Access Compliance Report Public Rights-of-Way (Pedestrian Signals)

Main Street: **LOS ALAMITOS BLVD** Cross Street: **ROSSMOOR WAY** Location: **NE**

ADA ID: **SGRK211217125724** Signal Type: **One Push Button-Non APS** Overall Compliance: **No** Severity Scores: **BTN 1: 10** **BTN 2: N/A** **No BTN: N/A**

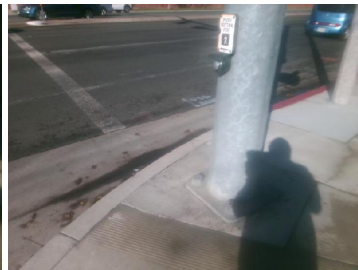
Possible Solutions: Replace Signal Push Button With APS Button.
